**RE: STAGE 3 (DFO) EASTERN CREEK QUARTER
PROPOSED CHURCH STREET TRAFFIC SIGNALS**

**RE: STAGE 3 (DFO) EASTERN CREEK QUARTER
RESPONSE TO MATTERS RAISED BY TFNSW**

1. As requested we have reviewed the matters raised by TFNSW in its letter dated 30 March 2021. The matters raised and our response is set out below.

12.5m LARGE RIGID VEHICLE
SWEPT PATHS - BEGGS
ROAD LOADING DOCK

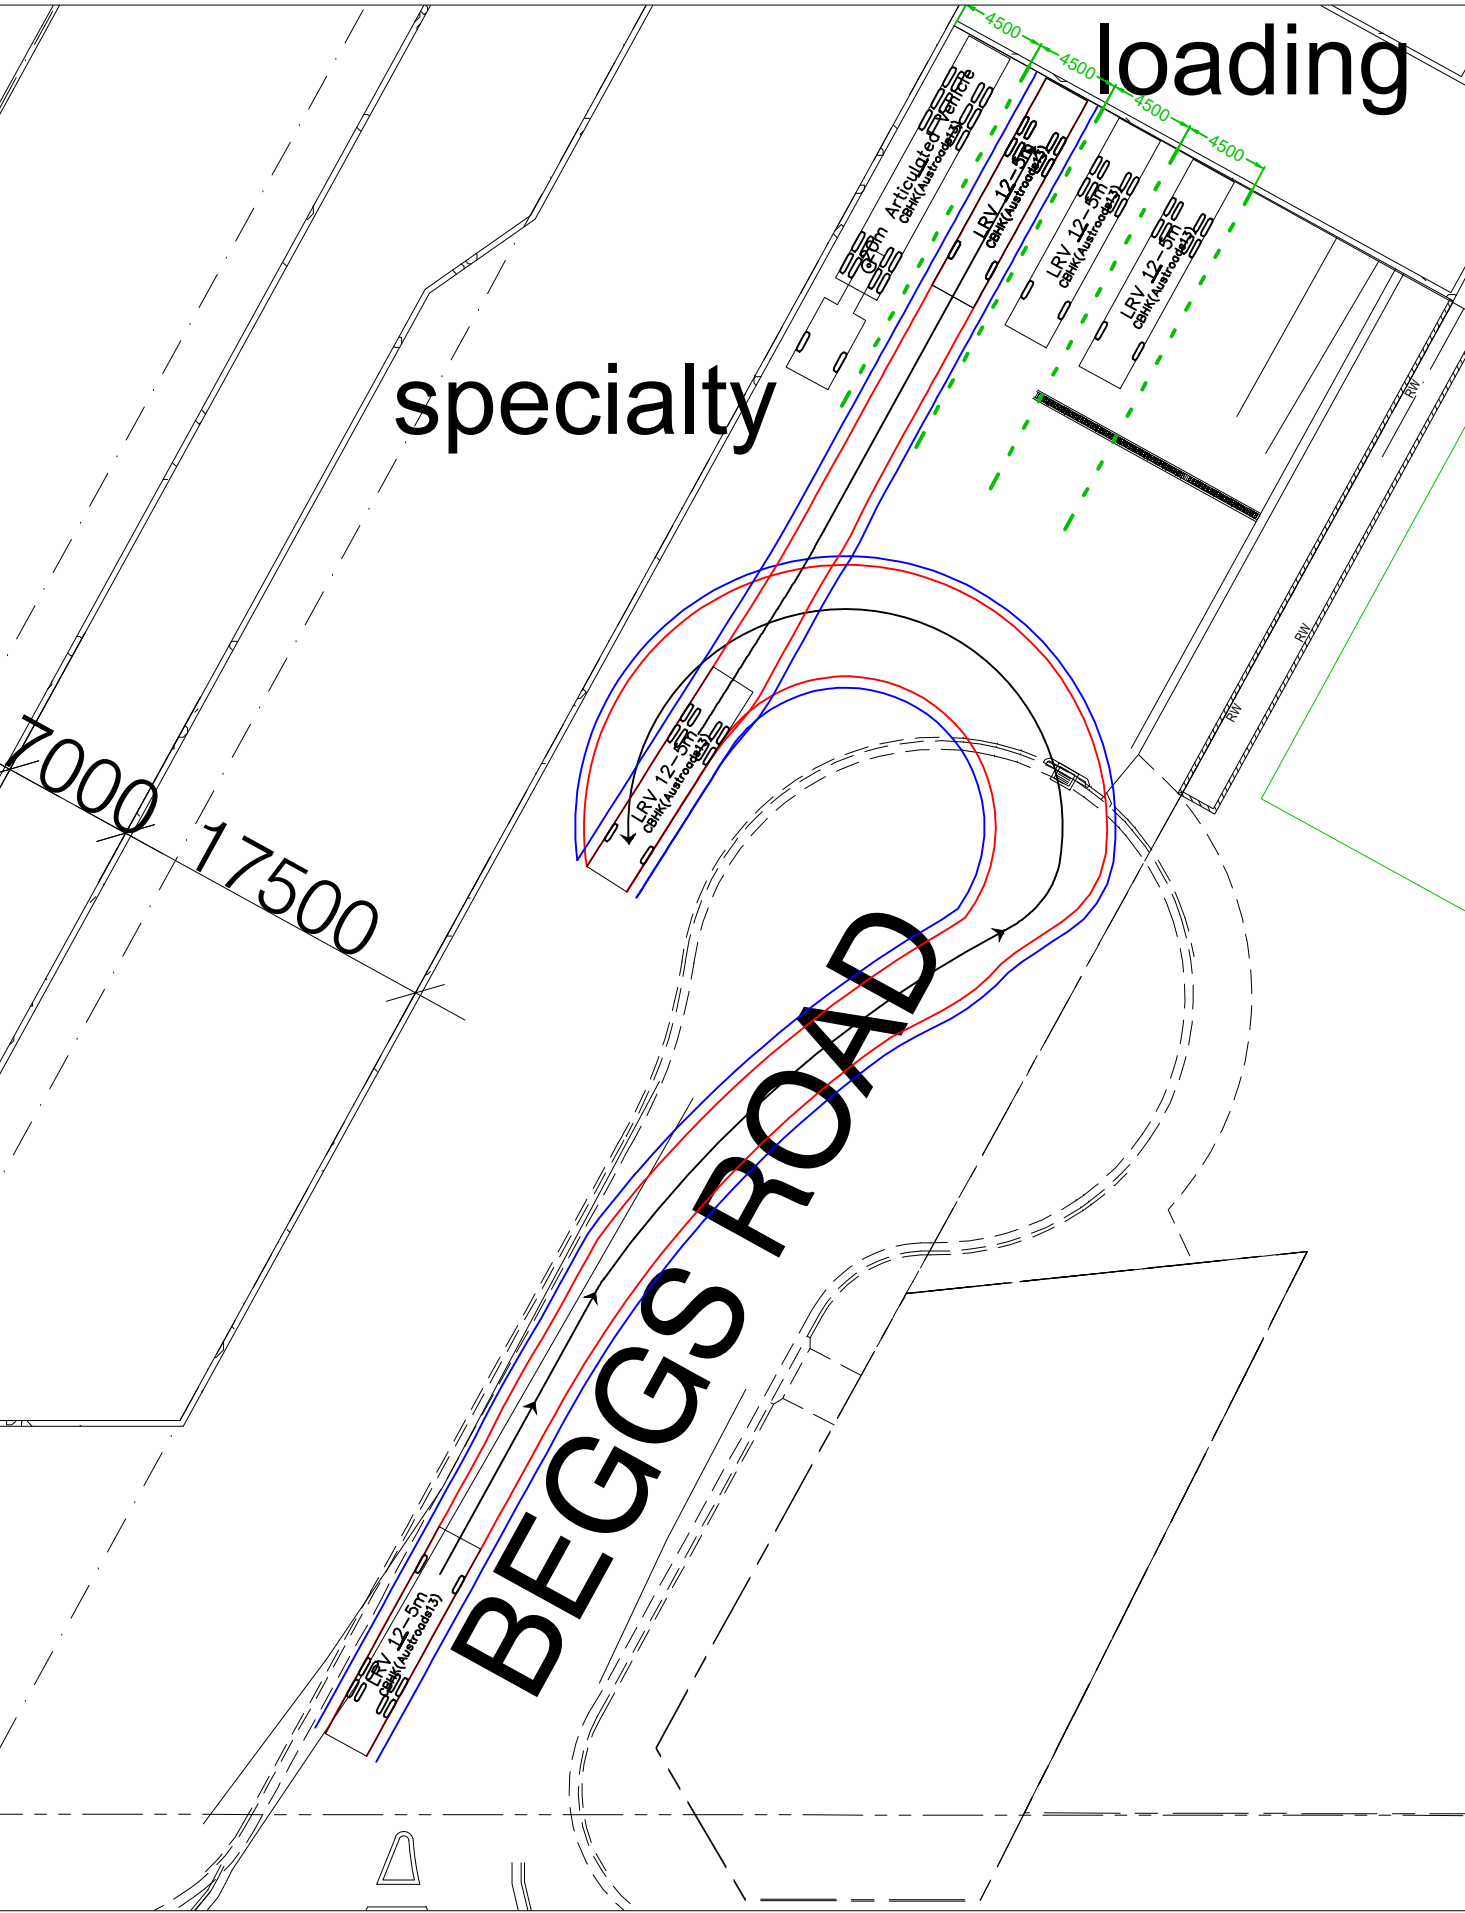
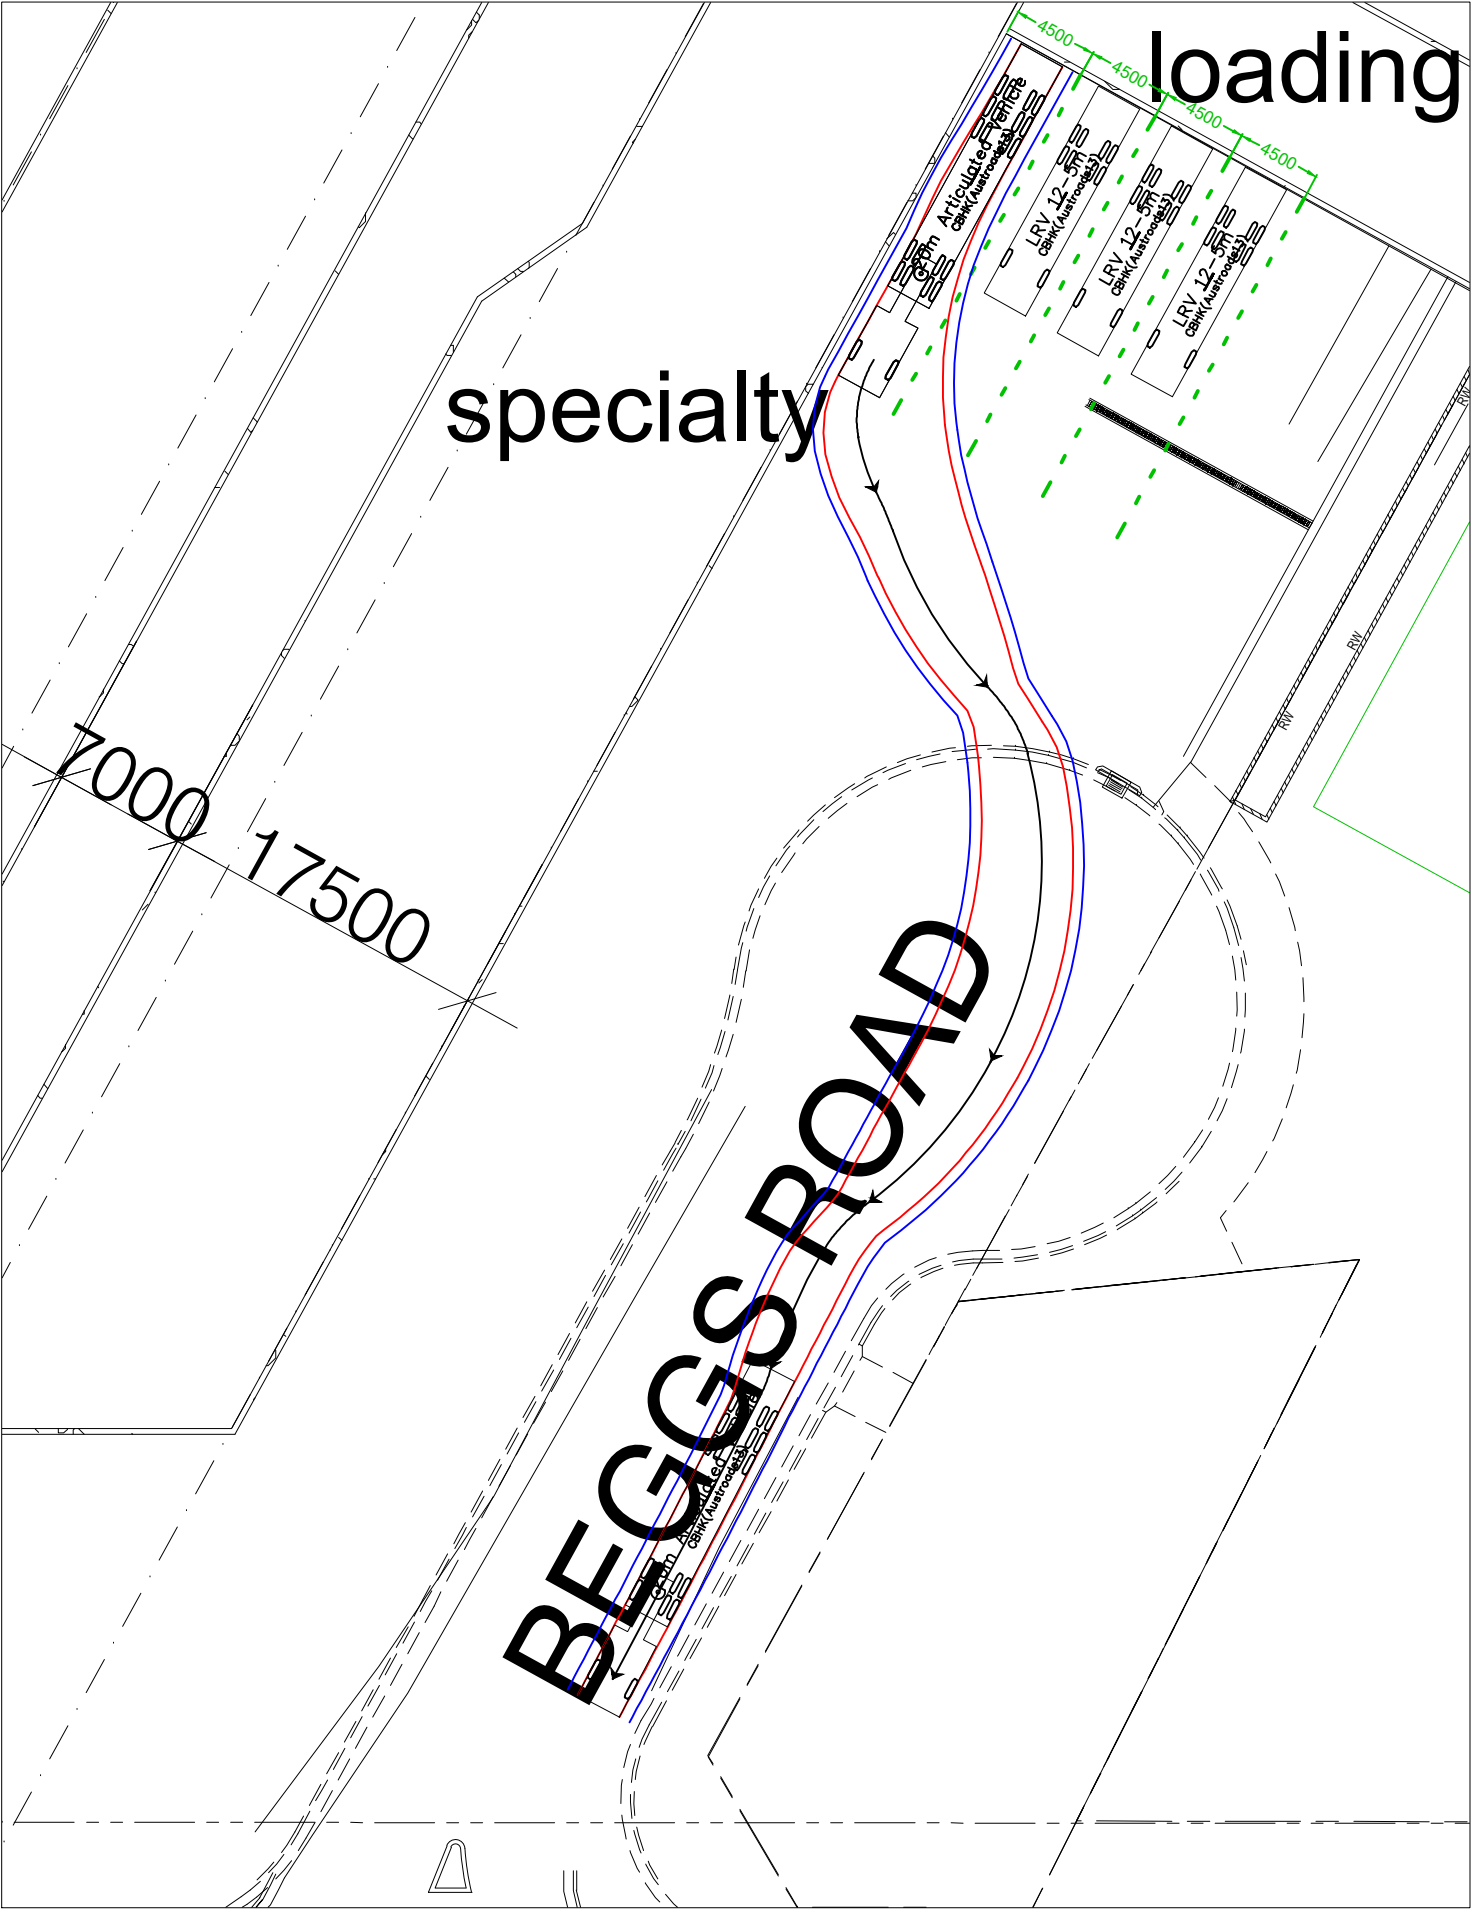
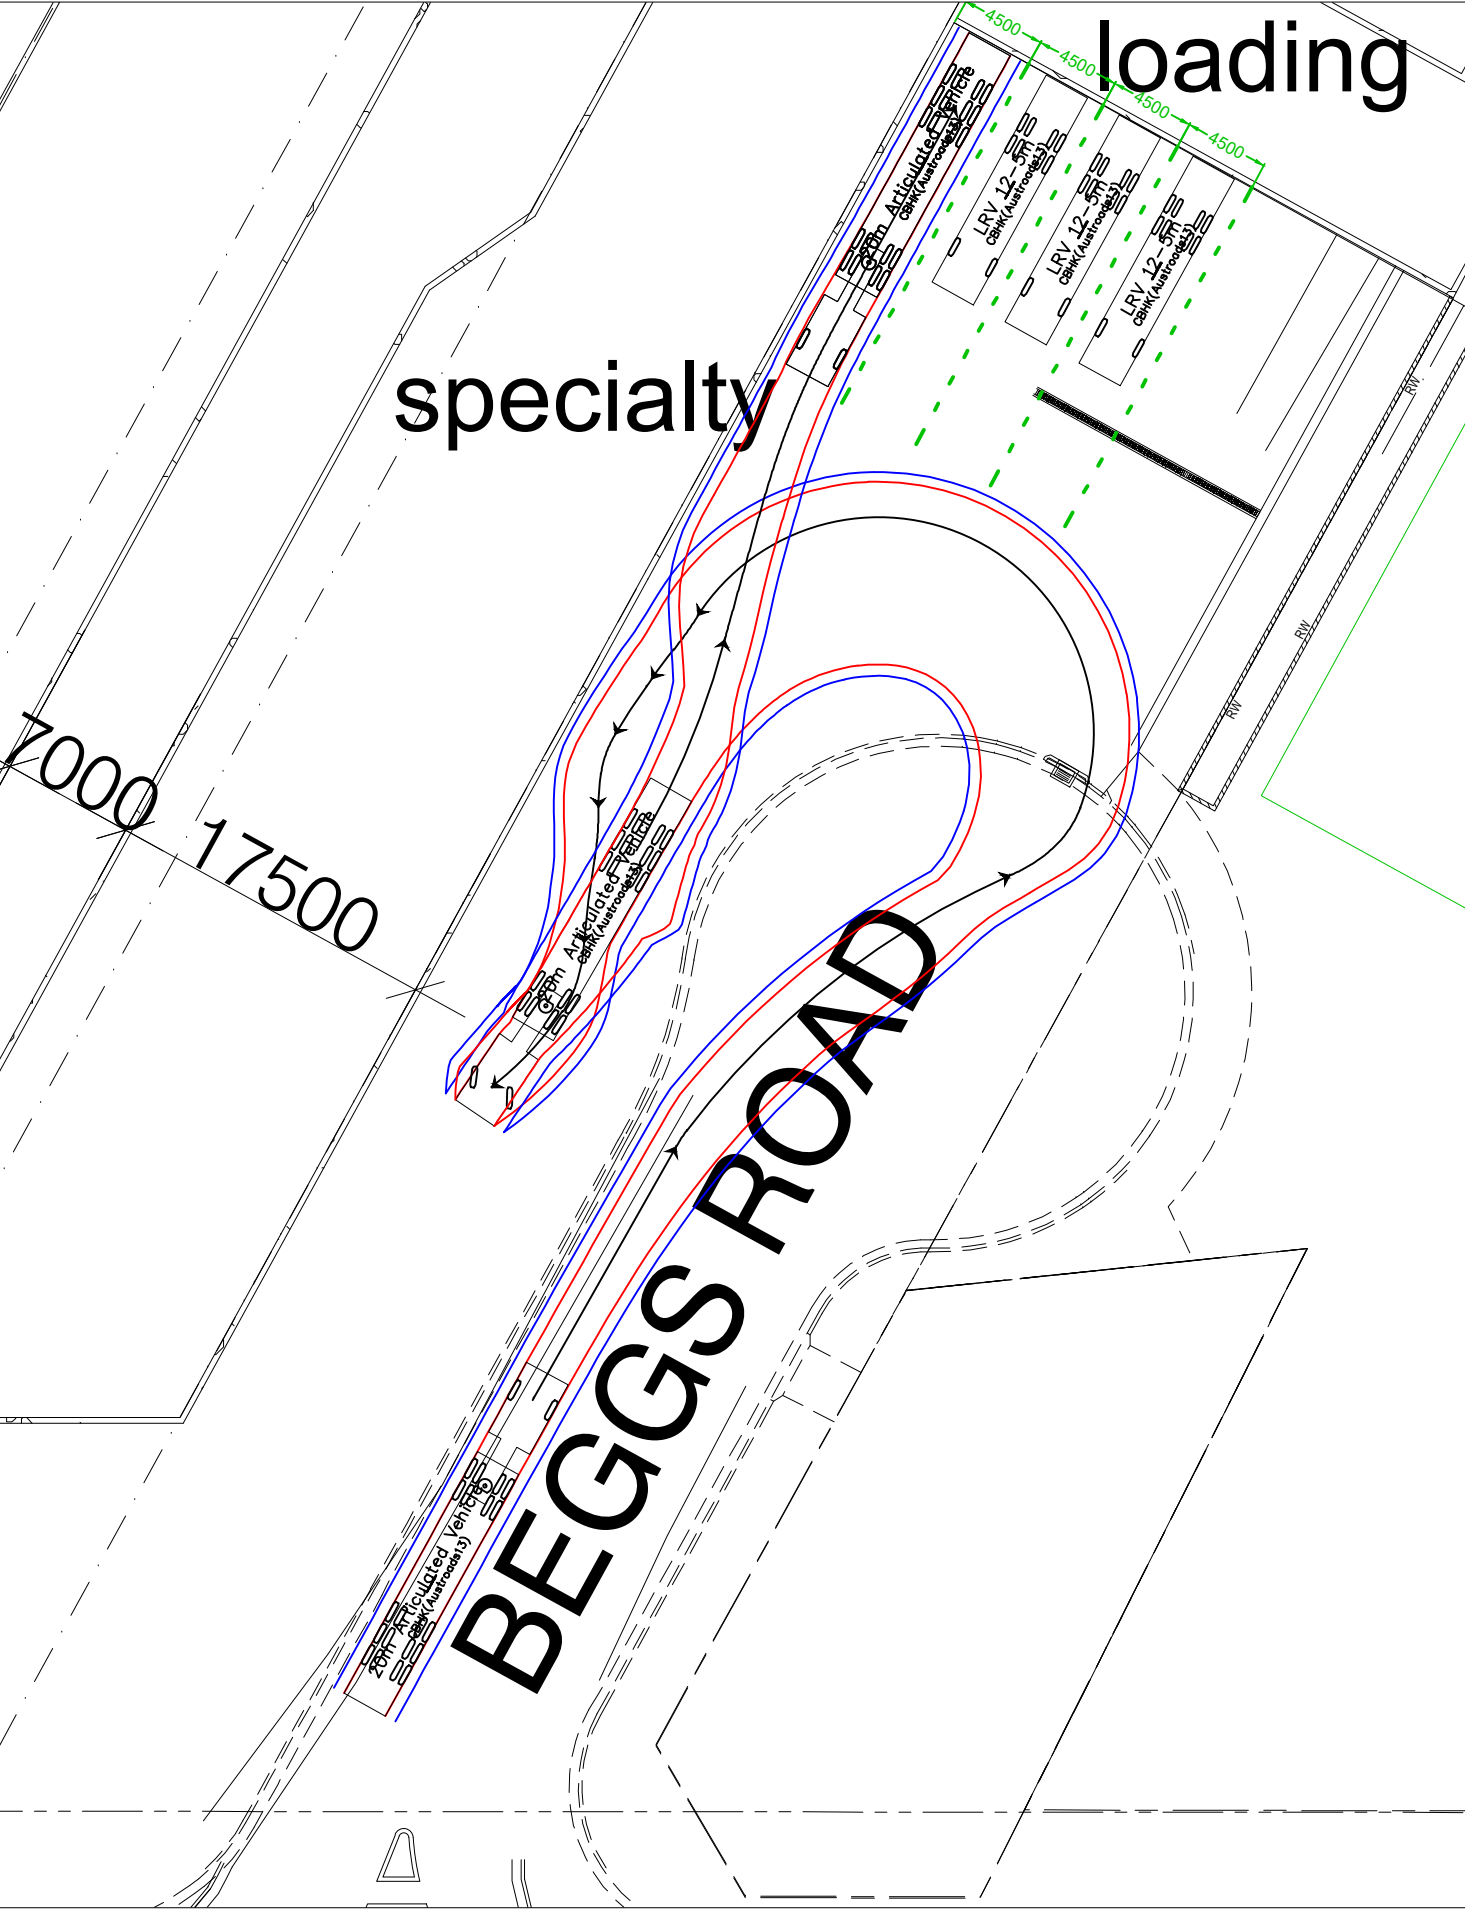
Any changes to the approved Beggs Road layout needs to identified in the plans. Furthermore, swept path plans needs to be provided for any changes to the access via Beggs Road

19. Beggs Road currently provides left in/left out access from RHRS to the service area for Lot 2. There is no internal vehicular connection between the Lot 2 service area and Lot 2 car park. Stage 3 proposes that Beggs Road would also provide access to a service access for Lot 3. No car park connection would be provided for Lot 3 from Beggs Road. No changes are proposed to the Beggs Road connection to RHRS. Truck swept paths for an indicative service area for Stage 3 are provided in Attachment E. We note that this will be further refined as part of the DA for Stage 3.
20. We trust the above provides the information you require. Finally, if you should have any queries, please do not hesitate to contact us.
